Pete Cooper Tract A 2025 Subdivision PRELIMINARY PLAT

**ITEM #4 - PRELIMINARY PLAT
Pete Cooper Tract A Subdivision**

KPB File No.	2025-098
Plat Committee Meeting:	August 11, 2025
Applicant / Owner:	Peter Allen and Elaine K. Cooper of Ninilchik, Alaska
Surveyor:	Jerry Johnson / Johnson Land Surveying
General Location:	Sterling Hwy Mi 126.5 / Ninilchik

STAFF REPORT

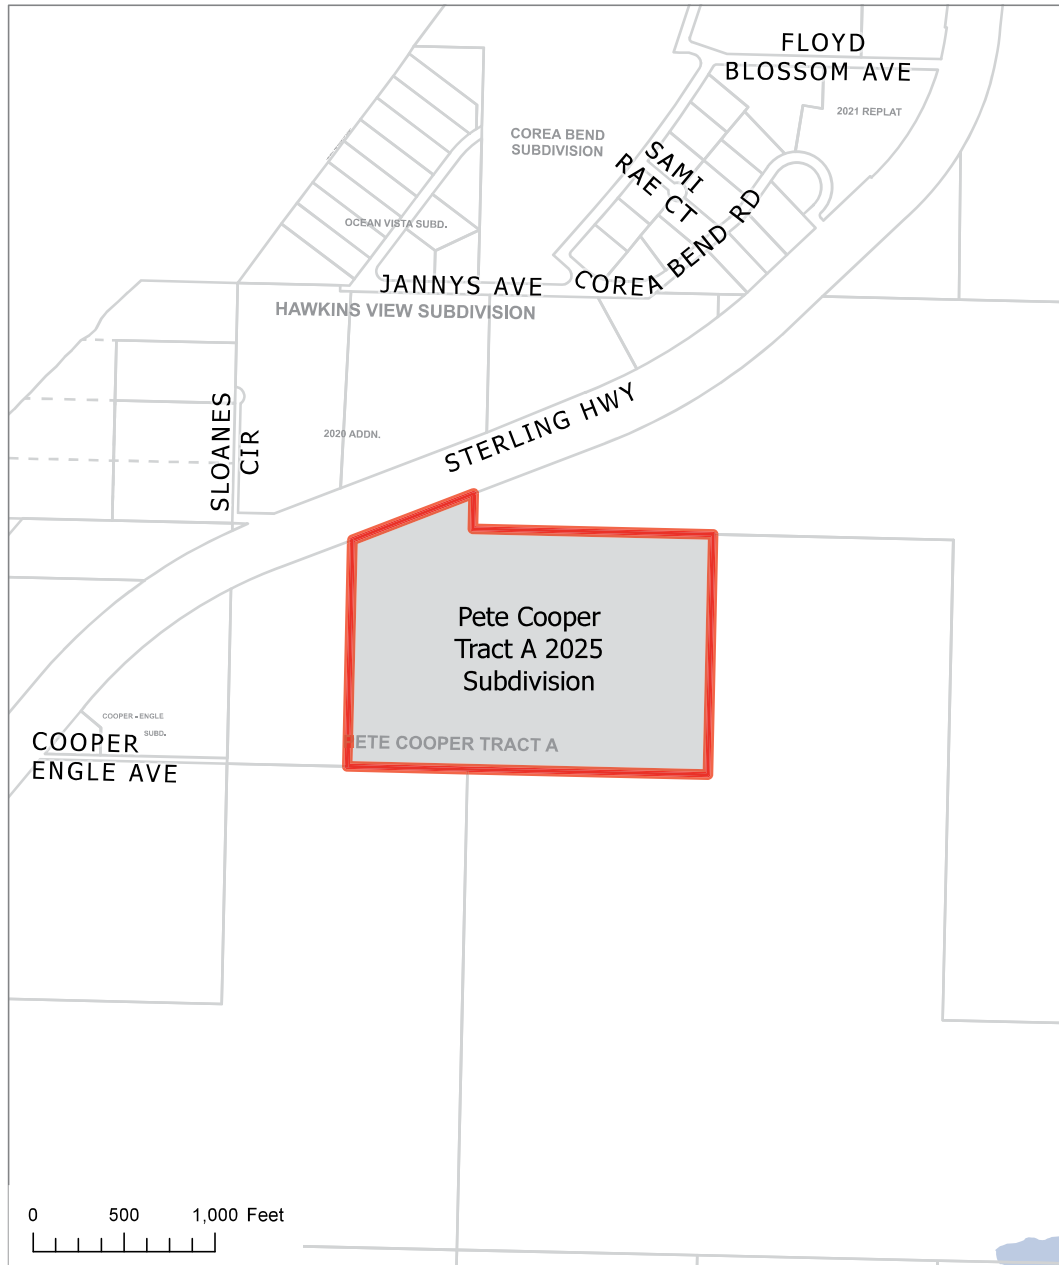
The 100' transmission line easement shown on the plat and note 6 was carried forward from the parent plat. **Staff recommends** this be noted as being carried forward from HM2003-84 and modify the plat note to remove the "granted by this plat".

The parent plat included a plat note for a 20-foot-wide easement on the overhead power line located to the north. **Staff recommends** Plat note number 6 should be carried forward from the parent plat referencing the overhead powerline and a label should be included on the depiction referencing the plat note.

Right-of-way easements were granted to HEA by recorded documents book 50 page 55, HRD and Misc. Book 4, Page 150 KRD. **Staff recommends** the surveyor add the easement information to the plat.

- Add legend to drawing
- Add cap detail to the GLO/BLM monuments.
- Add Plat Approval note

Add KPB File No 2025-098 to the title block

Show Cooper – Engle Ave to the west

Show proper Wastewater Disposal note on drawing
